Hastings Secondary College Upgrade | Port Macquarie Campus / Response to DPIE Request for Information

SINSW SSDA — REV 1 — 13/10/21

## **Additional questions and request for information:**

South Elevation

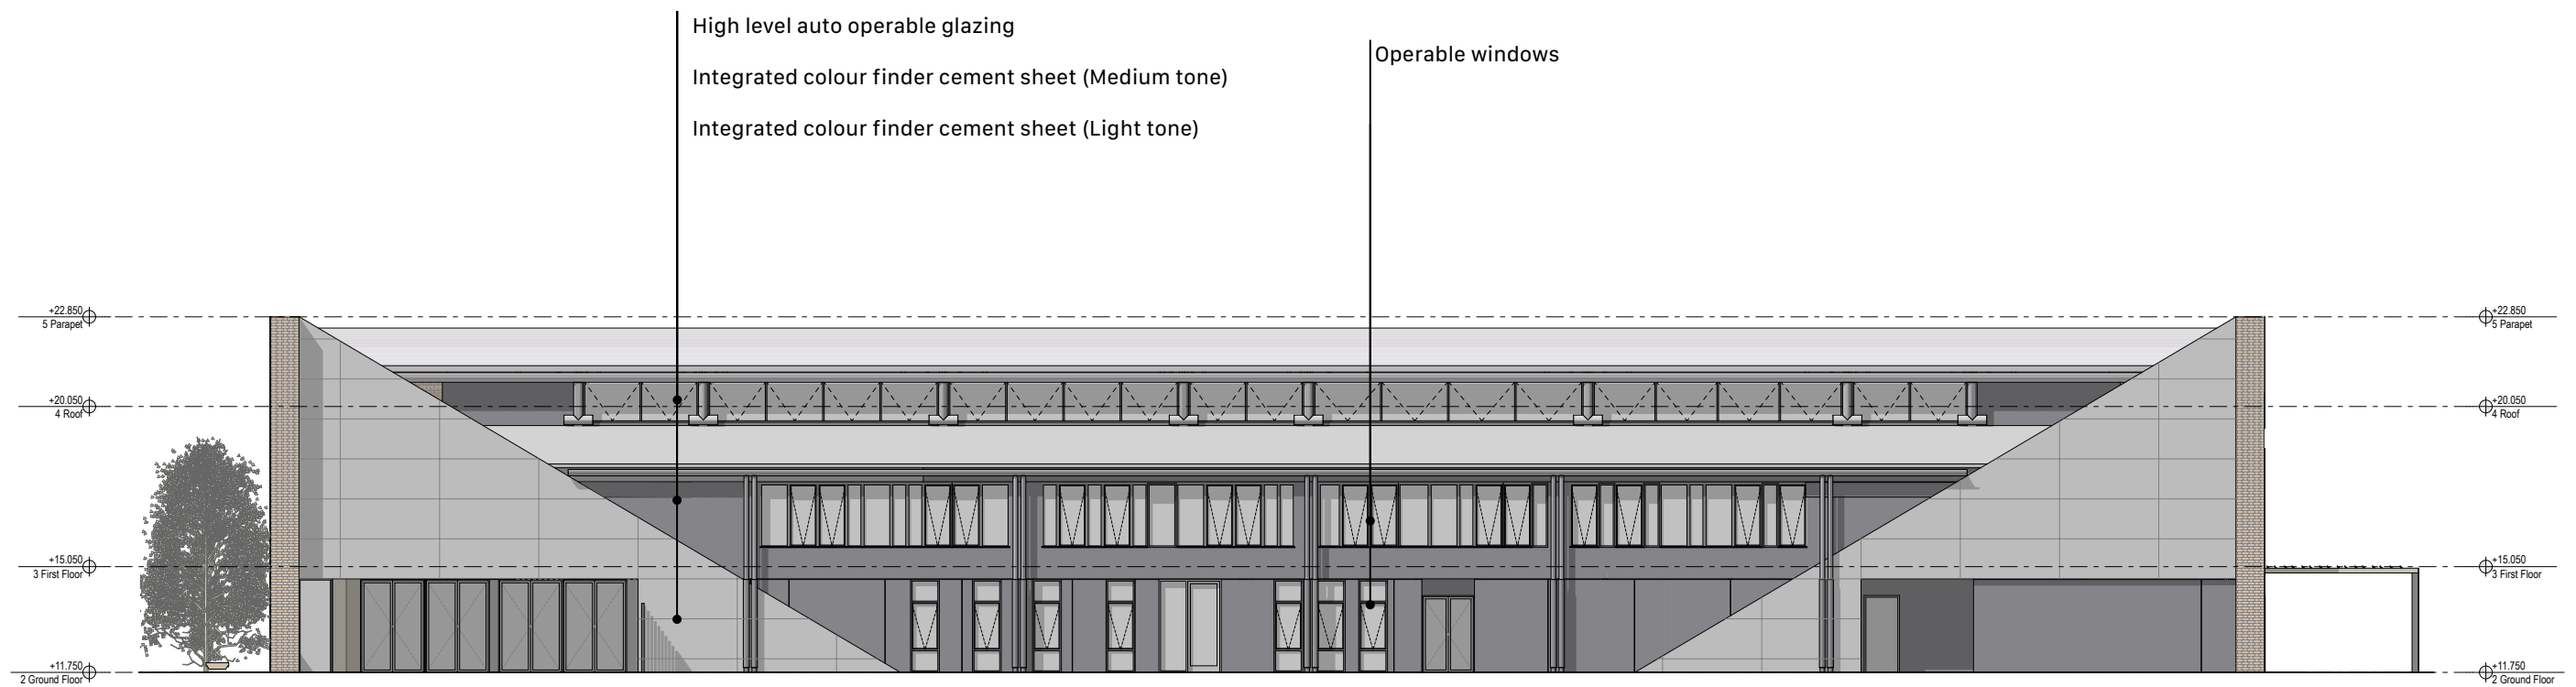
GANSW advice (dated 12th August 2021) recommended that detail be provided demonstrating how the extensive circular west facing aperture on the PCYC relates to place, in particular micro climate, thermal comfort and glare, and how it is envisaged to be protected from western sun. Sole reliance on high performance tinting or glazing is to be avoided.

The East and West elevations of the PCYC, SSDA-310200-Revision 04 indicates that the extensive circular east and west facing apertures consist of dark coloured performance glazing. It is recommended that alternative options for solar performance be investigated.

An additional layer of detail has been provided following on going design development to address the acoustic and thermal performance of the facades.

Circular window

To the west and east this window will be protected externally by fixed powder coated aluminium louvres. These louvres will be supported by a suppressed framing system so that the horizontality of the louvres remains the dominant feature. The window to the west is fixed glazing to address acoustic requirements but to the east has an

element of operability to meet the required 5% natural ventilation of all non air conditioned areas (Courts, Foyer and Circulation).

Internally the western window will have a projector screen which will also act as a brown out blind.

West/East Link

The west/east link is proposed to be experienced as a clear glazed link separating the courts and the support spaces. To maintain a high level of transparency a larger format external powder coat aluminium louvre is used to the west. Similar to the western circular window, the link glazing to the west is fixed. The link glazing to the east will be large format glazed louvres with expressed framing.

# PCYC Ground Level Plan

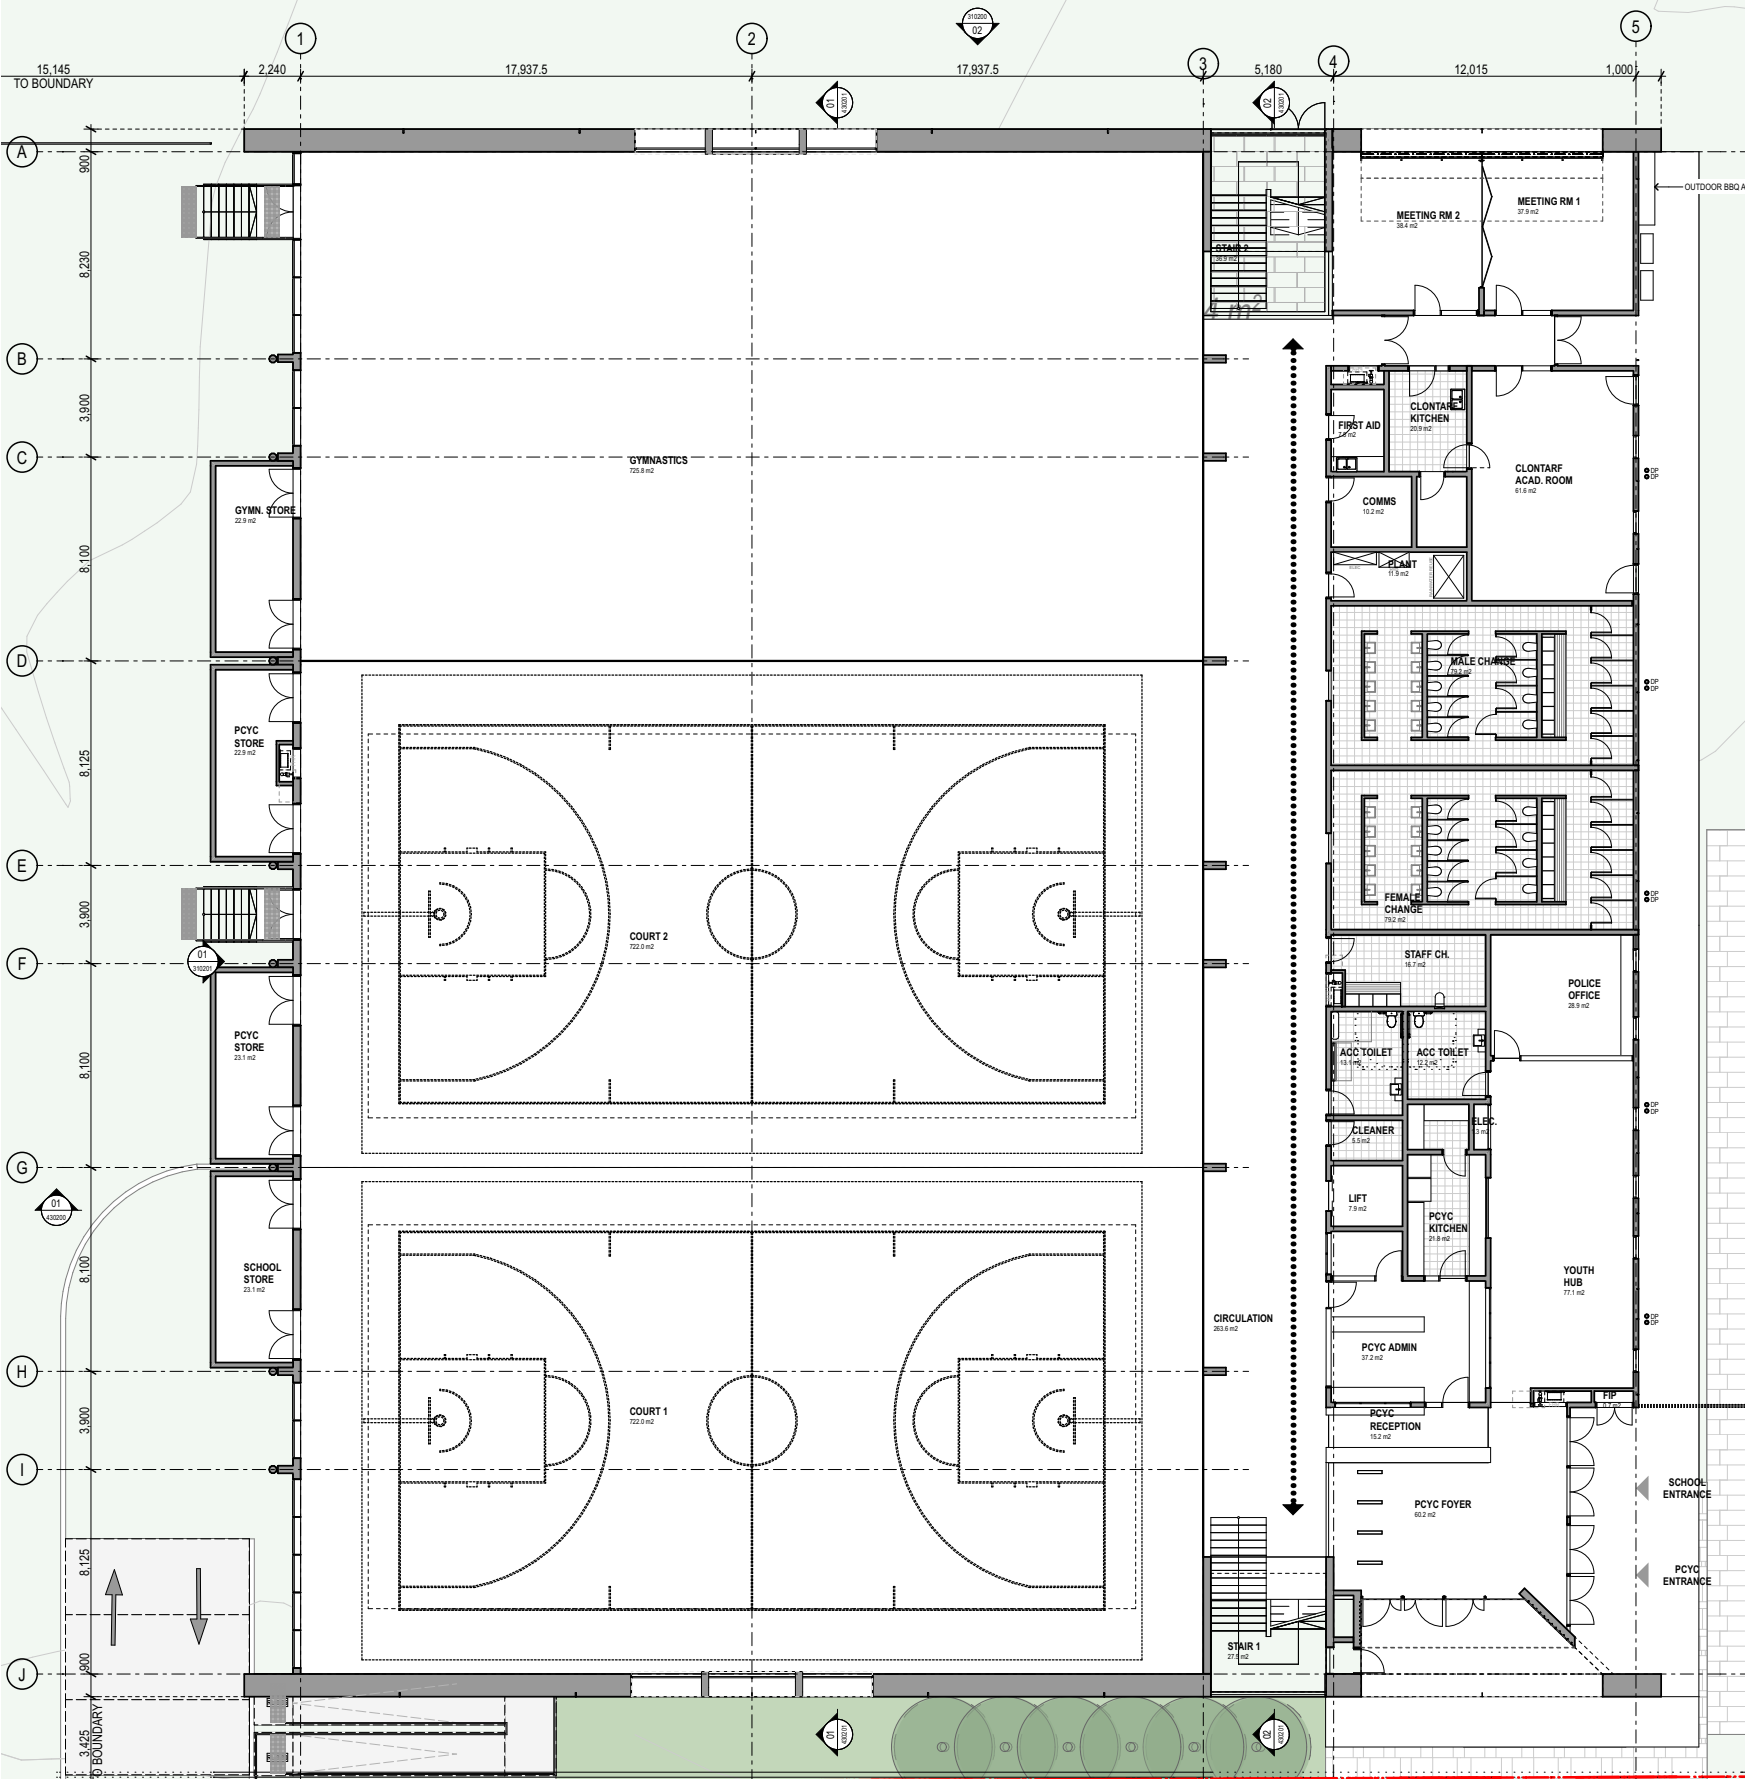
*GANSW advice (dated 12th August 2021) recommended that detail and sections through new and refurbished built form (be provided) to demonstrate how passive design strategies will contribute to the 4 star Greenstar target and ensure that access to natural light and ventilation are provided and maximised for all internal spaces.*

The PCYC will be ventilated with a combination of natural ventilation (Courts, Circulation including stairs and foyer and the lower ground car park), mechanical ventilation (Amenities and Stores) and air conditioned spaces (Multi purpose Rooms, Gymnasiums, Meeting Rooms, Learning Spaces and Administration spaces).

### Natural Ventilation

Openable windows or louvres are provided to the north, east and southern facades, plus roof mounted cowls. The majority of the natural ventilation is focussed at low level to the north and east to enable air to be drawn across the space. Additional high level ventilation is provided at the high level and full height to the east.

All other non service areas with the exception of the Administration Office have direct facade natural ventilation. The Administration Area is visually and at time, physically, open to the Foyer and the Courts due to its function, therefore will utilise borrow natural ventilation from these spaces.

### Mechanical Ventilation

All support areas will be mechanically ventilated as required by the NCC. Note that the courts will have large roof top mounted mechanical vents with fans to provide exhaust air.

Large ceiling fans will also be provided in the Gymnastics Court.

The courts are daylight through both the eastern and western circular windows, which will be protected with fine external louvres and high level windows at roof level.

# CAPA Ground Level Plan

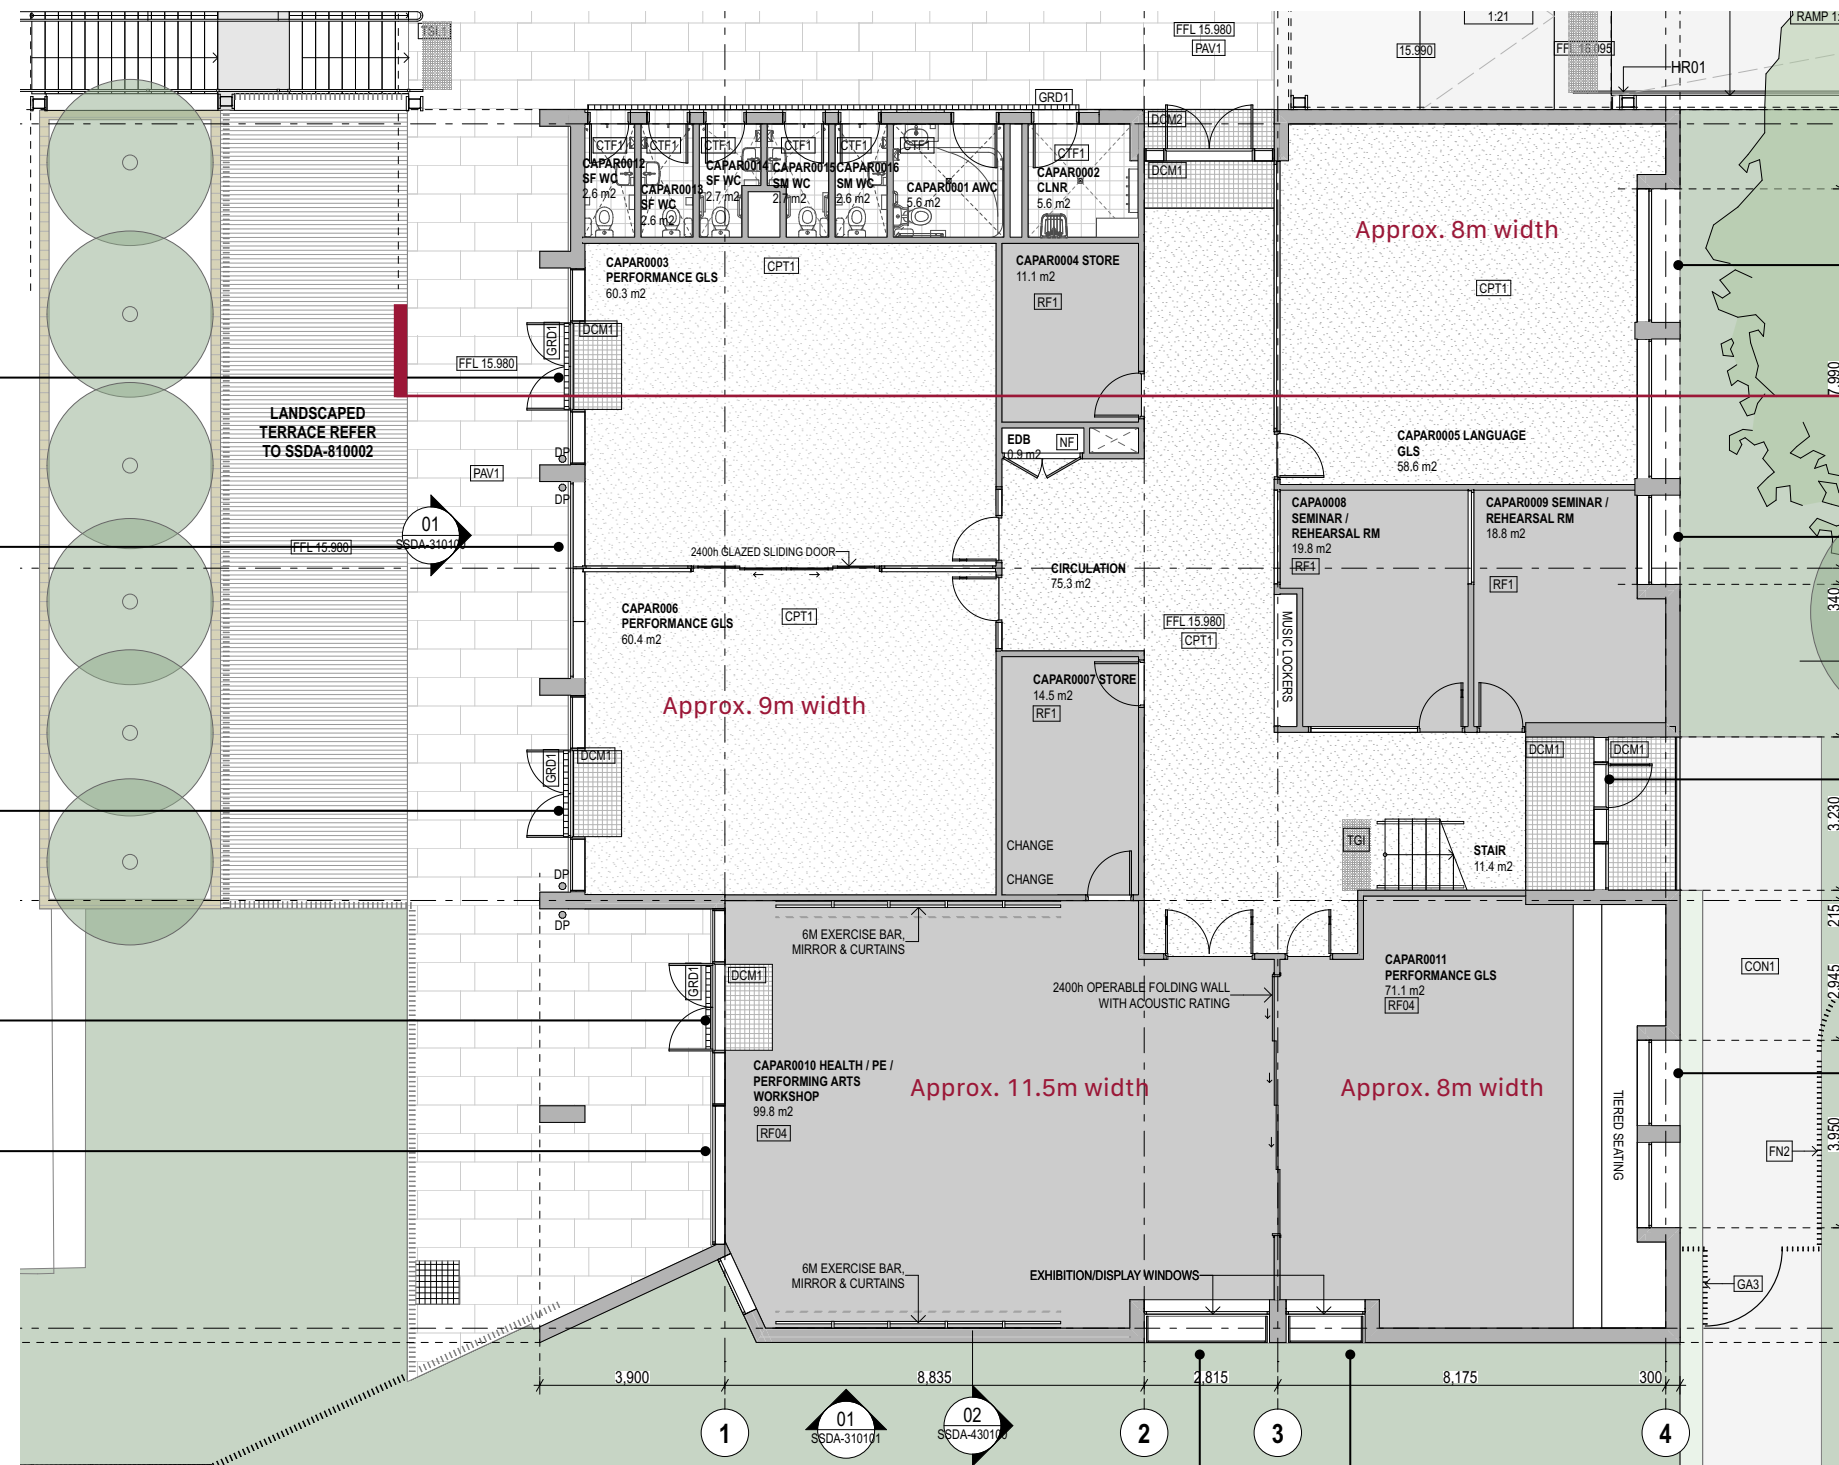
*It is recommended that opportunities for operable glazing be investigated in the CAPA building, which appears to have predominantly fixed glazing.*

**Each window bank to have a zone of mechanical fresh air intake louvres. In active louvres to be blanked off.**

**Windows recessed between brick piers/  
columns to provide east/west shading**

2 x aluminium framed glazed door with operable glazed louvre side lights.

2 x 3 x glazed openable awning windows (with limiters) - 1000 mm - 2400 mm.

2 x glazed openable awning windows (with limiters) - 1000 mm - 2400 mm.

- 2 x 2 x glazed openable awning windows (with limiters) - 1000 mm - 2400 mm.
